STAFF RECOMMENDATION 1115 Greenwood Avenue October 19, 2016

Application: New construction – infill; Setback determination
District: Greenwood Neighborhood Conservation Zoning Overlay
Council District: 06
Map and Parcel Number: 08301046400
Applicant: John Pirtle
Project Lead: Melissa Sajid, melissa.sajid@nashville.gov

Description of Project: Application is to construct a new single-family residence and includes a right side setback determination to reduce the street-side setback from ten feet (10') to nine feet (9').

Scale 3/16" = 1' FRONT
 ELEVATION

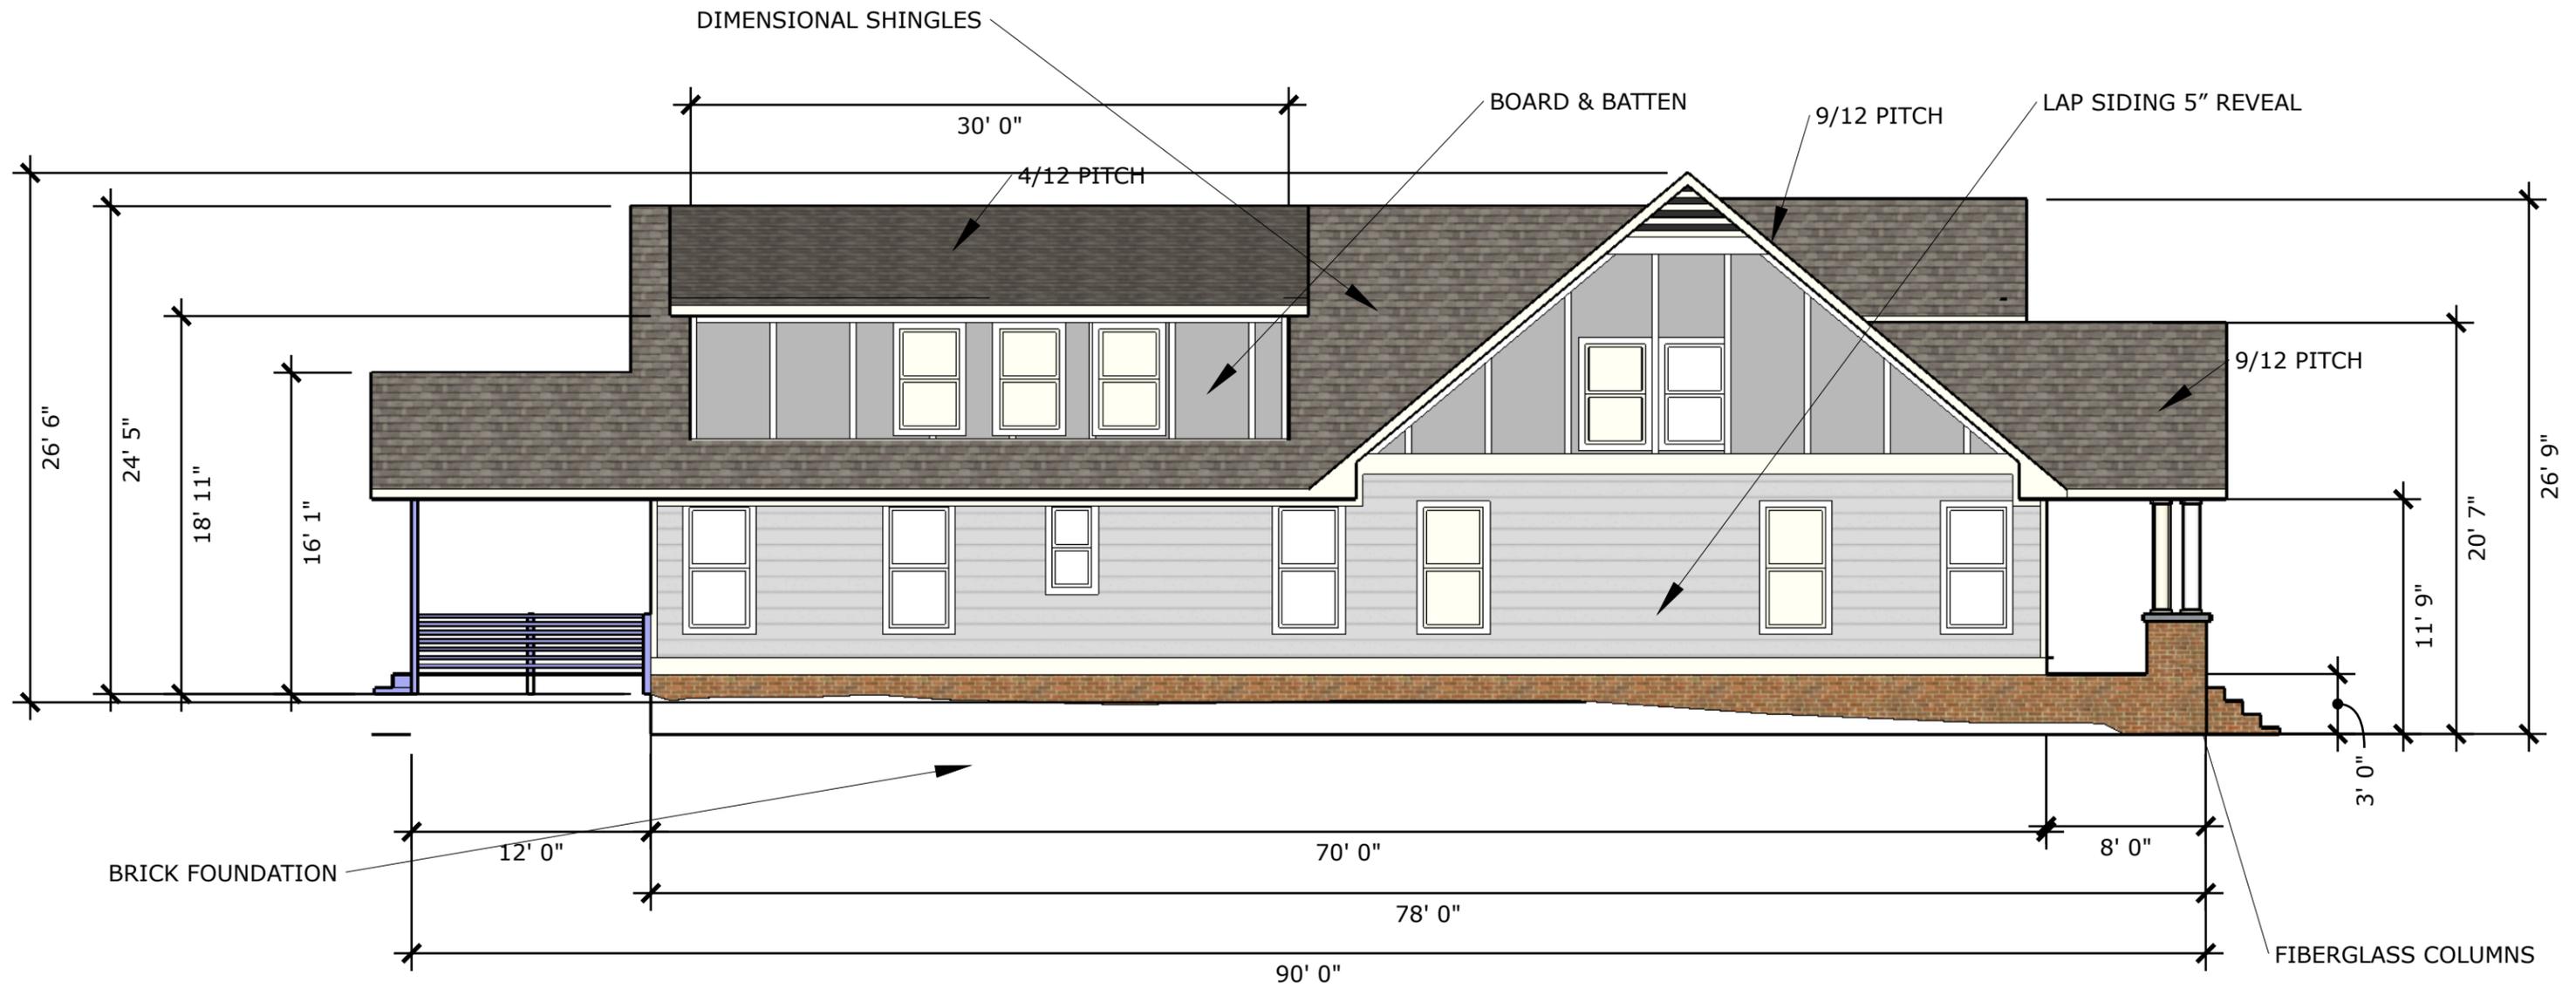
Staff recommends more detailed drawings be submitted prior to issuance of a permit so that the project is clearly communicated to the inspector. A true front elevation that is to-scale is needed, the front drawing does not show a railing, which will likely be needed, the floor plans do not show the front and rear porches, corner boards are not shown on the rear elevation, the depth of the porch floor is not indicated, and the rear porch posts do not line up with the roofing above.

5. The HVAC shall be located behind the house or on either side, beyond the mid-point of the house;
6. More detailed drawings shall be provided prior to issuance of permit;
7. All paired windows have a four inch to six inch (4"-6") mullion between windows; and,
8. Staff approve the masonry color, dimensions and texture prior to purchase and installation.

Scale 1/8" = 1' RIGHT ELEVATION

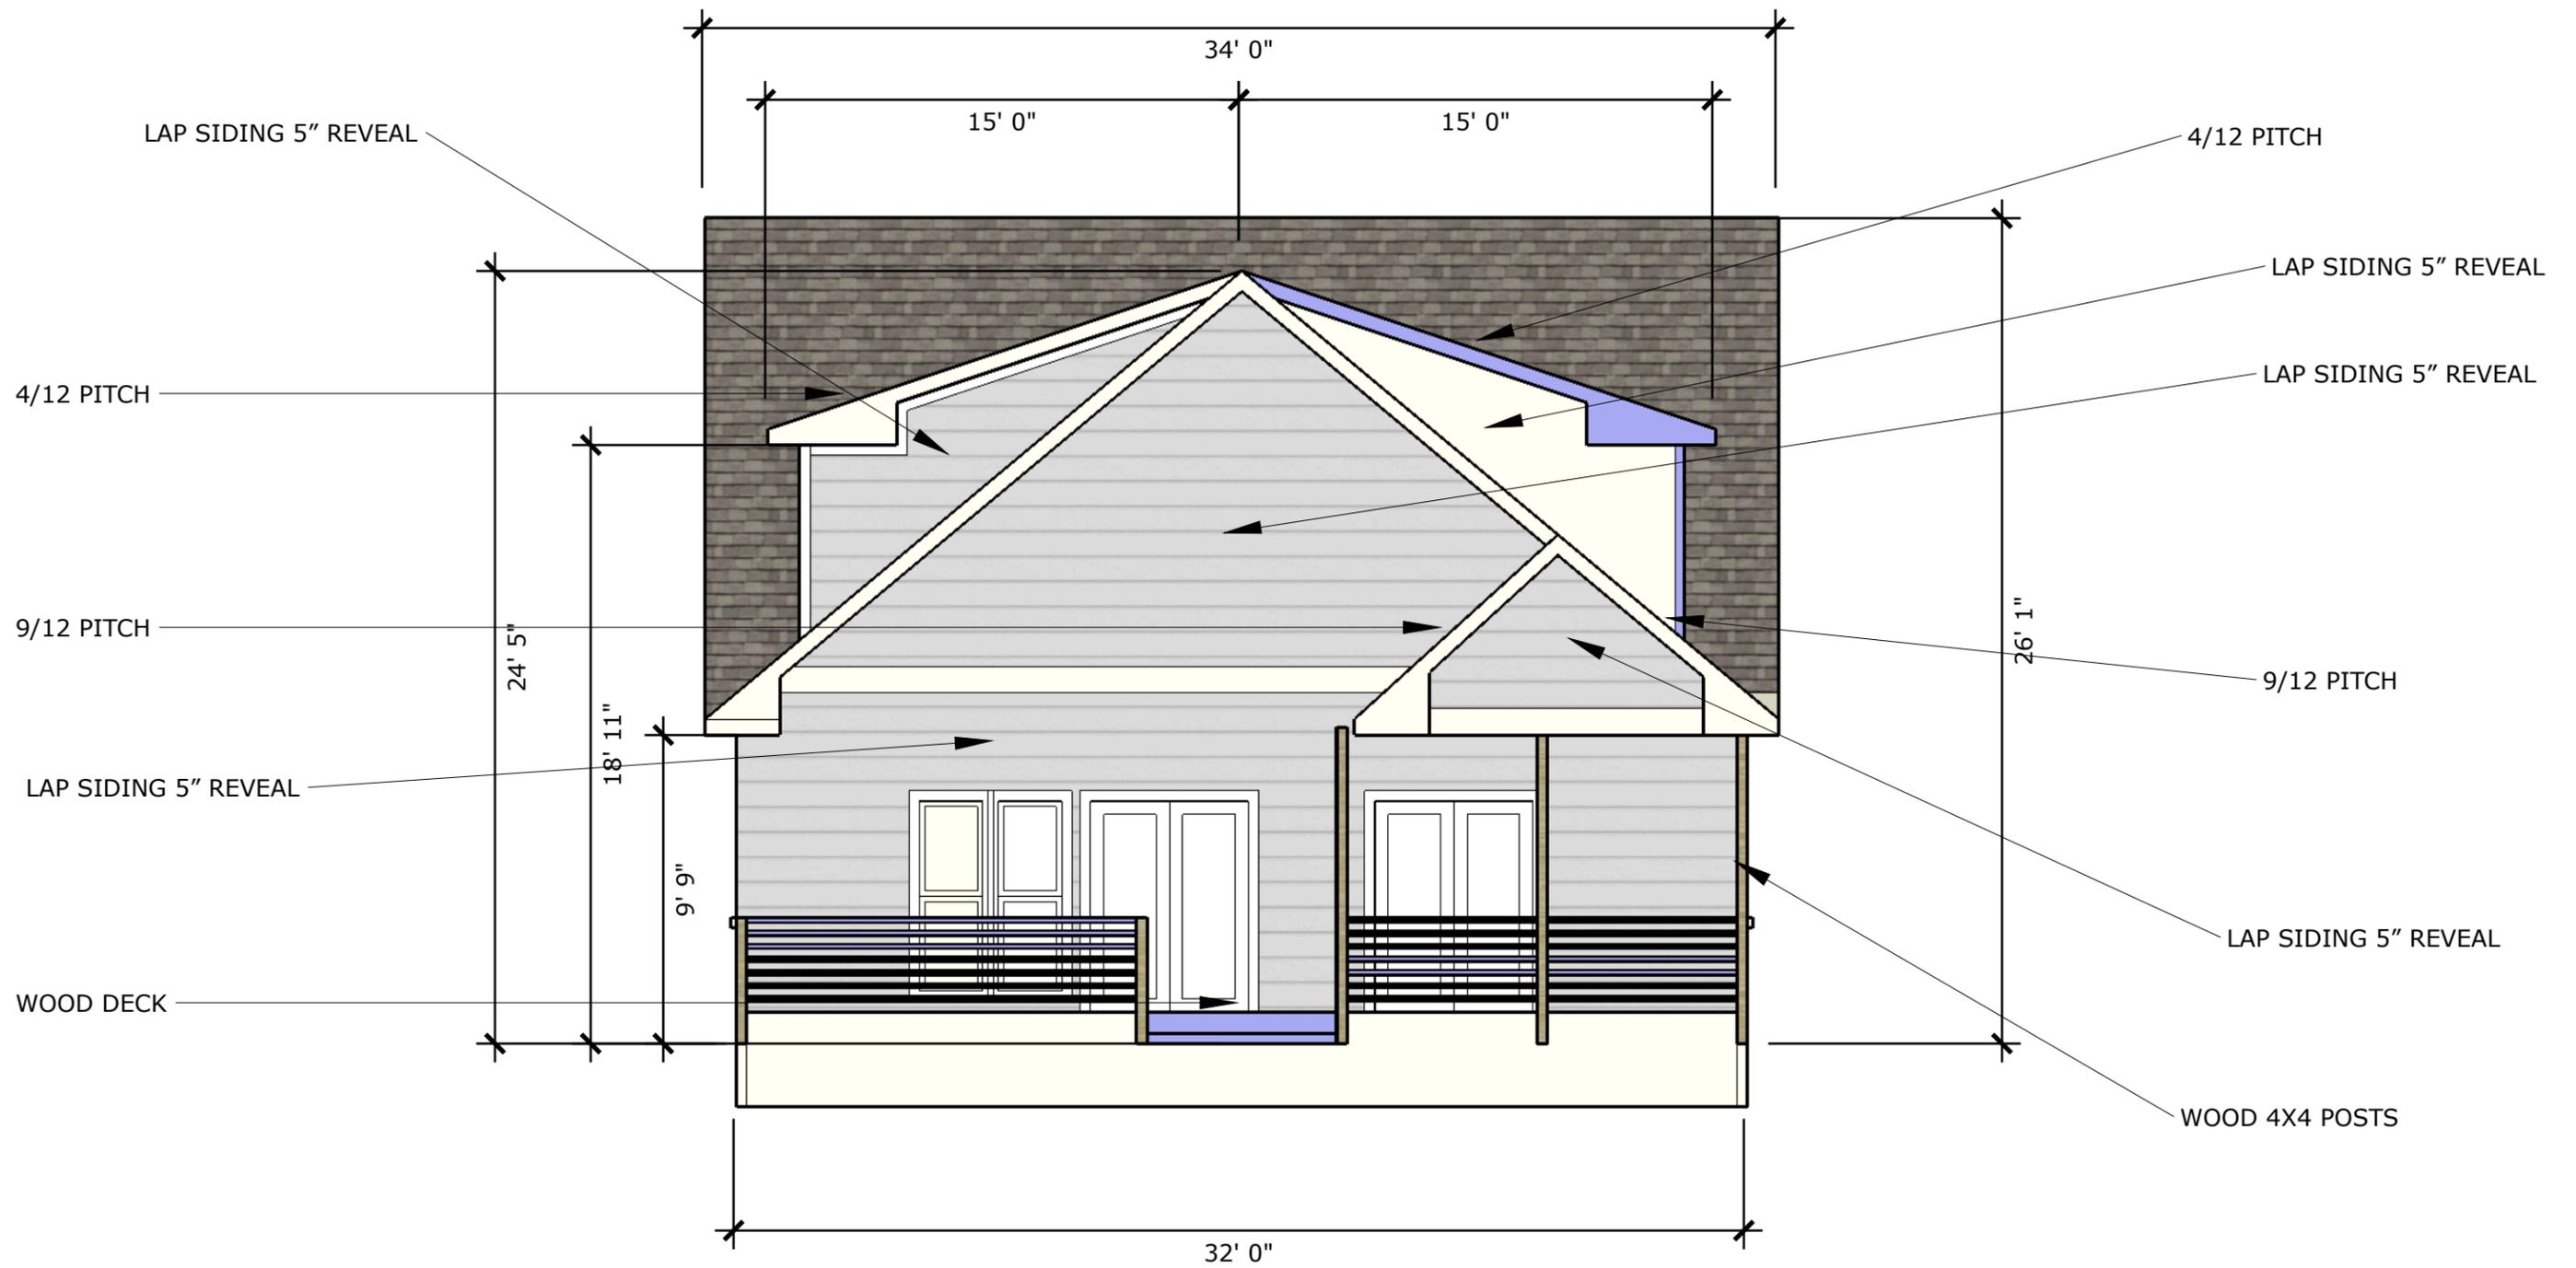
As the house is located on a corner lot, the minimum setback on the side street is ten feet (10'). The applicant has requested a right side setback determination to reduce the setback from ten feet (10') to nine feet (9'). Staff finds that reducing this side setback is appropriate. The lot is narrower than the typical lot in the immediate area, so reducing the right-side setback allows for a building footprint that is more appropriate for the context. In

Staff finds that the setbacks to be appropriate and recommends approval of the setback determination. Staff finds that the project meets Section II.B.1.c.

STREET SITE
 PLAN

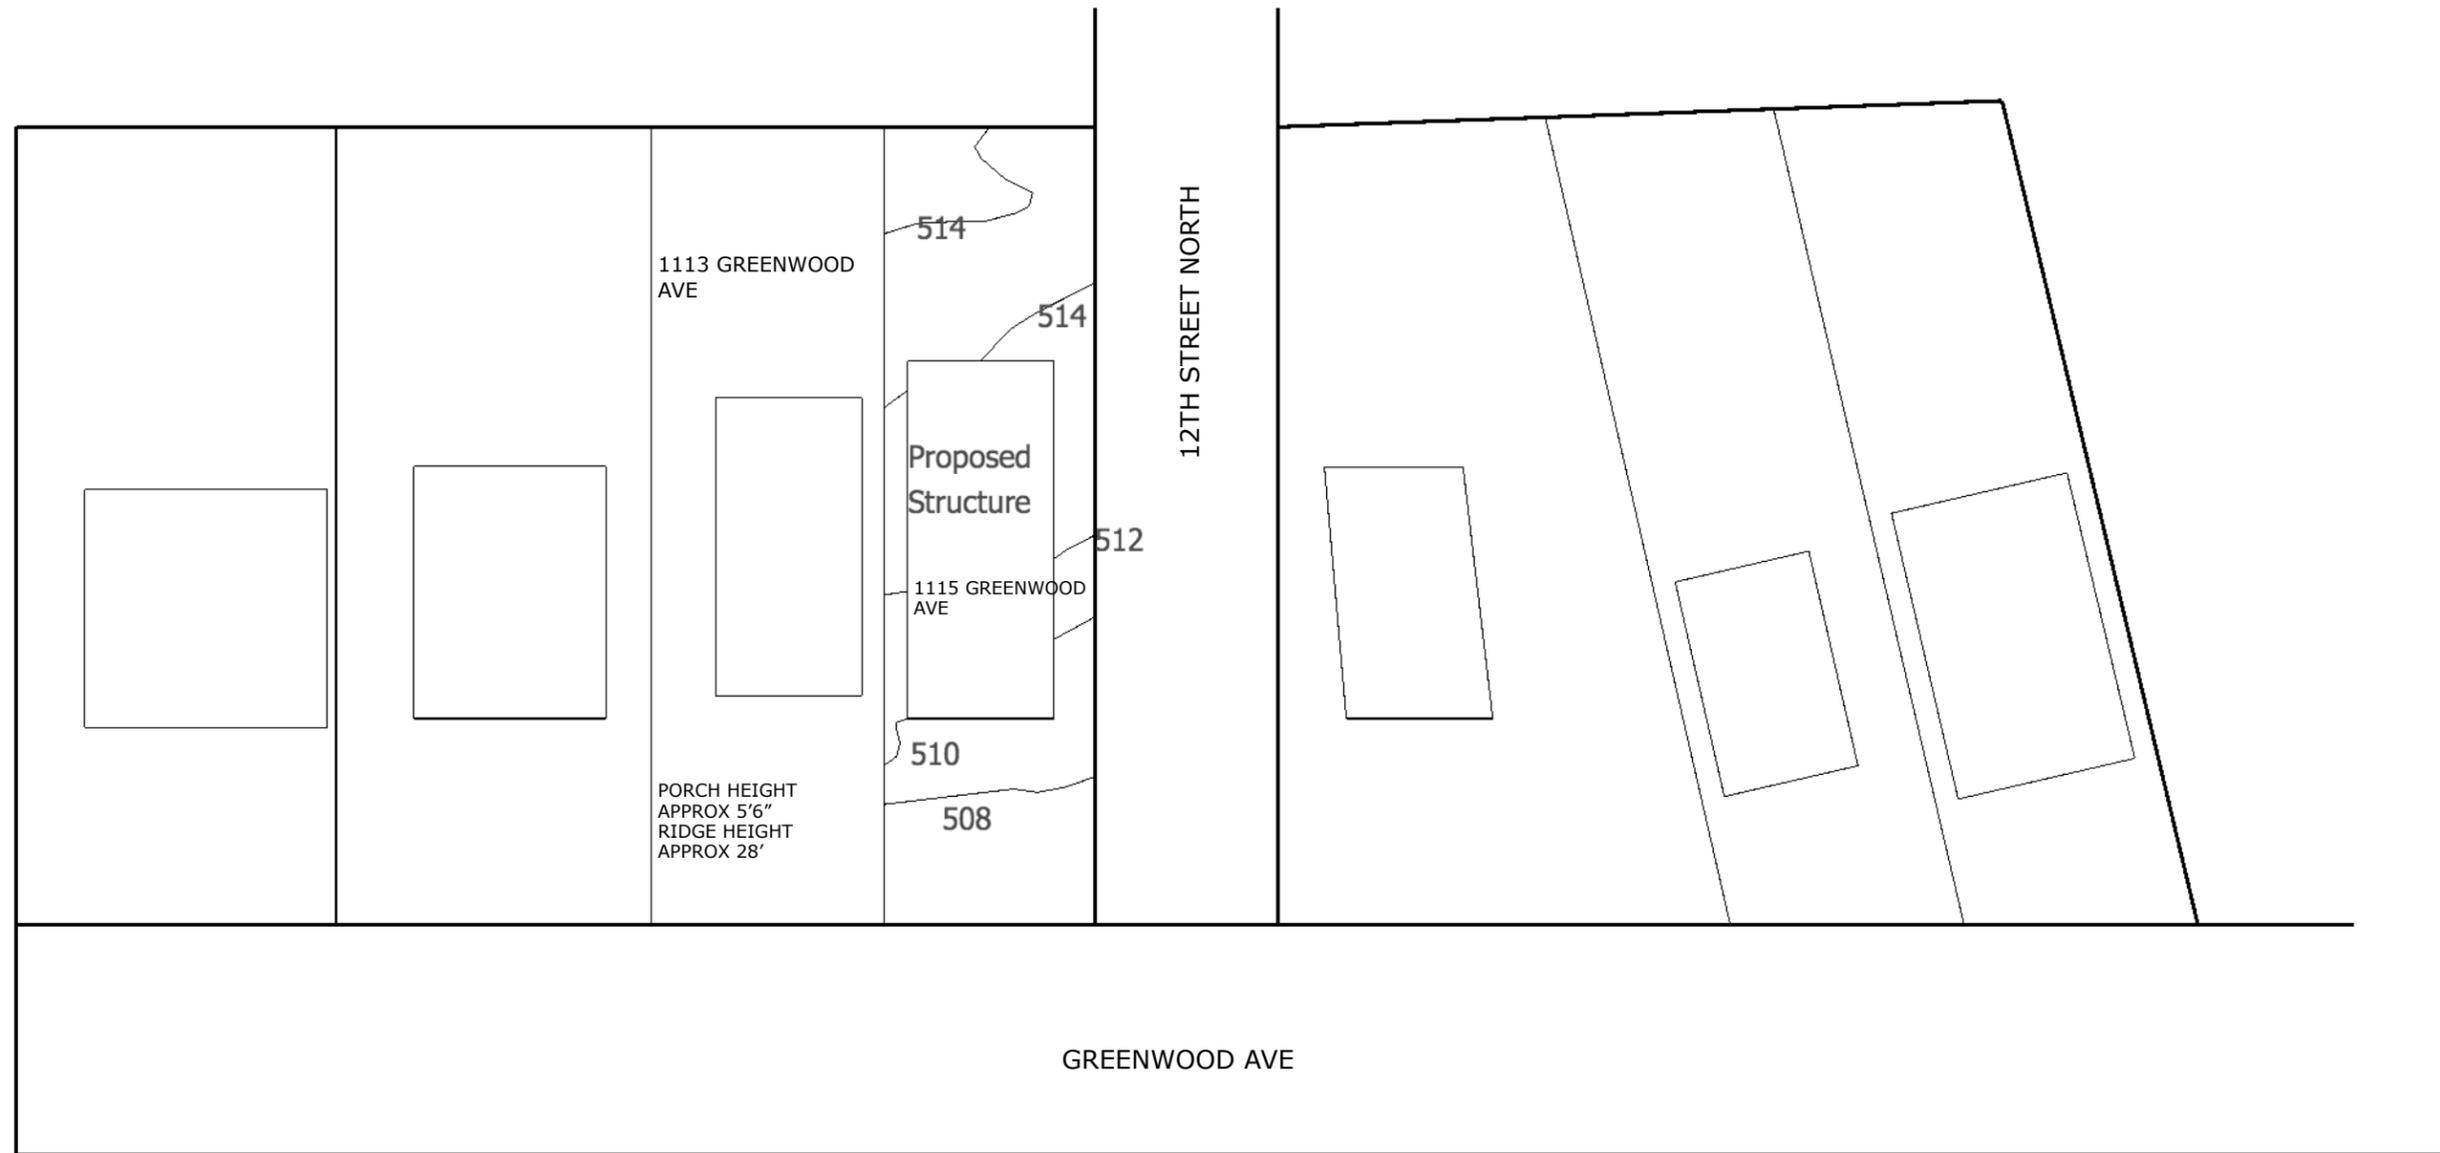
Setback & Rhythm of Spacing: The proposed infill meets the bulk standards for the rear and left side setbacks; however, it does not meet the bulk standards for the front and right-side (street side) setbacks. The proposed front setback of forty-five feet (45') is inconsistent with the setback of the historic house to the left, which is set back fifty feet (50') from the property line; however, it is consistent with the home to the right, across North Twelfth Street and with one home over to the left.

Appurtenances & Utilities: The site plan does not indicate the location of the HVAC. Staff recommends that the HVAC be located behind the house or on either side, beyond the mid-point of the house. With this condition, staff finds that the project can meet Section II.B.1. i.
